Subject: Dresden Nuclear Power Station Units 2 and 3
Commonwealth Edison's (CECo) Review of the NRC Systematic
Evaluation Program (SEP) Concerns Regarding CECo's Validation of
the Design Basis of the Containment Heat Removal System
NRC Docket Nos. 50-237 and 50-249

An Evaluation of LPCI Heat Exchanger Flow Parameter Changes on the NRC SEP Containment Analysis for Dresden Station

Figure 1

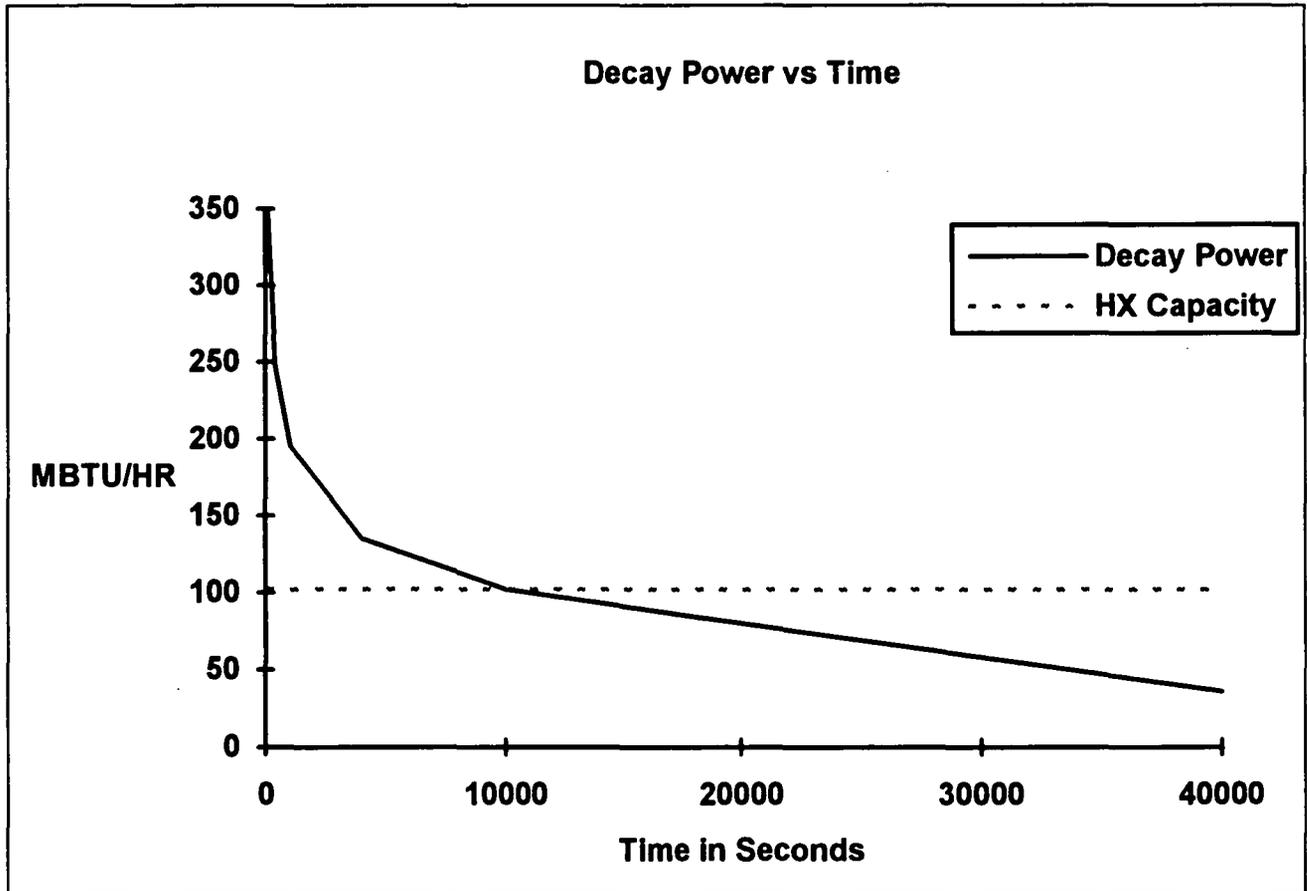
3. The containment temperature, particularly the wetwell temperature, should continue to rise due to the addition of decay heat until the heat exchangers balance the heat addition. Figure 1 includes a plot of the stated decay energy used compared to the heat exchanger performance at the FSAR design point referenced by the analysis (165 F suppression pool). As can be seen, the balance does not occur between containment heat removal and decay heat addition until approximately 10000 seconds (if the suppression pool is at least 165 F and the service water is 95 F, $\Delta T = 70$ F). Based on review of the analyses, the turnaround point

occurs at 600 seconds for the large break with a delta T of 73 F, 11000 seconds for the small steam break with a delta T of 43 F, and 3000 seconds with a delta-T of 66 F for the 1.0 FT2 steam break. It is noted that earlier turnover would be possible if a second LPCI HX were assumed operable, however, this would be inconsistent with the single failure of a diesel generator assumed in the evaluation.
